DRAWING AMENDMENTS

Applic.No. 10/689,671 Amdt. dated 5/3/2006 Reply to Office action of 9/15/05 Annotated Sheet Showing Changes

Fig. 2B

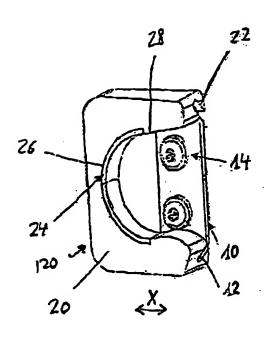
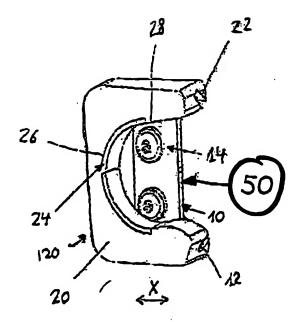
The attached sheet of drawings includes changes to Figs. 1 and 2B, i.e. reference numeral 50 was added to indicate the ratchet. This sheet, which also includes Figs. 2A and 3, replaces the amended drawing sheet submitted on June 20, 2005.

In "Drawings", item 1 on pages 2-3 of the above-identified Office Action, the Examiner objected to the drawings as not showing the ratchet means of claim 8.

In fact, the ratchets have always been shown in the drawings, but without a reference numeral, and claim 8 and paragraphs 0021 and 0022 have always described the ratchets. More specifically, claim 8 originally called for the first base plate 30 having a ratchet and paragraph 0022 of the Specification of the instant application called for the second base plate 10 having a ratchet.

Reference numeral 50 has accordingly been added to Figs. 1 and 2B. The Specification of the instant application has been amended to add reference numeral 50 thereto. As stated

above, the ratchets are located both on the roller 40 and on the base plate 10 which mutually engage, as well as on the base plate 30. Since both the structure of the ratchet and the description thereof were originally present in the disclosure as filed, no new matter has been added.
